**SERVICE BULLETIN**

**SB060-1001**

Subject: Legacy Inboard Gear Doors Reinforcements (Serial Numbers)

Status: Mandatory Compliance for Version 1 Inboard Gear Doors

Figure 1: Version 1

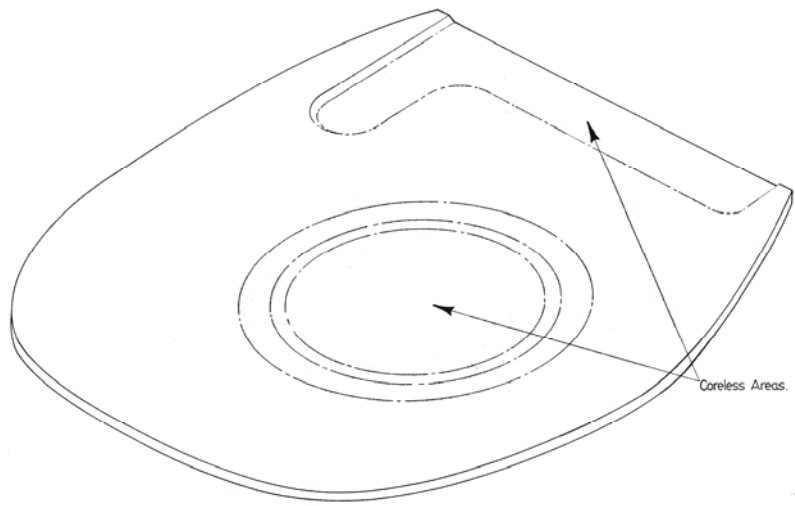
We have discovered an issue with the inboard gear doors. While inspecting the inboard gear doors of a Legacy in flight from a chase plane we noticed that the outboard end of the gear doors tends to remain slightly open in flight. The gear doors appeared to be approximately ½" open at the outboard end. We eventually attributed the problem to the stiffness of the gear door itself. This service bulletin explains how to identify the two different versions of gear doors issued by the factory. The initial production gear doors or version 1 will need reinforcements. The more recent gear doors, or version 2, already have the reinforcements incorporated.

1. Identify whether your gear doors are version 1 or version 2.

Version 1 of Left Inboard Gear Door: Serial numbers 2067 and below

Version 1 of Right Inboard Gear Door: Serial numbers 2072 and below

2. If you have a version 1 door, follow the instructions of blueprint #4762 and modify the door accordingly.
